Docket Item # 10
BAR CASE # 2017-00379

BAR Meeting
October 25, 2017

ISSUE: Certificate of Appropriateness (painting unpainted masonry)
APPLICANT: Amanda Bozzi
LOCATION: 309 North West Street
ZONE: RB / Residential

The applicant is requesting a Certificate of Appropriateness to paint the front elevation of the brick rowhouse located at 309 North West Street. The brick is variegated brown brick.

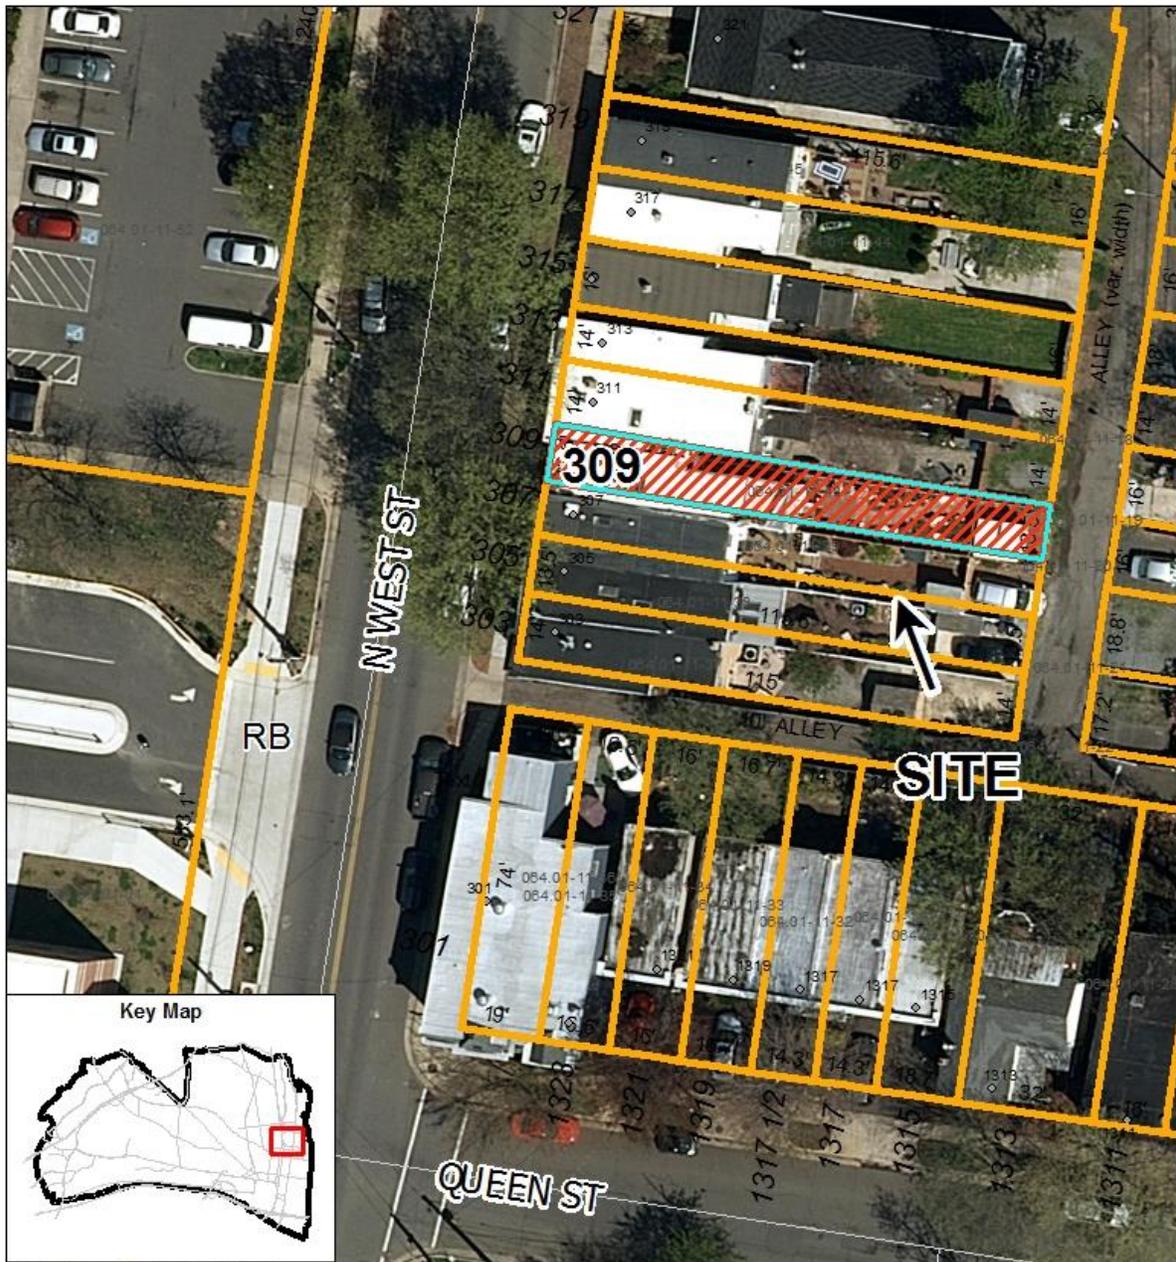
However, in this particular case, staff does not find that the late-20th-century variegated brick is a material worth maintaining and preserving as unpainted masonry, as it is visually unremarkable and the color and pattern of this brick are not characteristics found in the historic district. In fact, this brick rowhouse detracts from this streetscape which is predominantly historic two-story, two-bay frame, painted rowhouses (Figure 2). Painting this brick, an assemblage of brown variegated brick in no particular brick pattern of note, will improve the compatibility of this rowhouse with the overall block face.

The Uptown Parker-Gray National Register listing of 2010 states that this is a non-contributing resource and is "...of a very plain design." While staff is extremely cautious in recommending the painting of unpainted masonry for both Early and Later dwellings based on the discussion above, in this particular situation, staff can recommend approval of the painting of the late-20th-century brown brick on what is designated a Later building in the Parker-Gray District because it will promote compatibility with the nearby historic buildings and will not detract from the building's architectural character.

Staff recommends approval of the application as submitted.
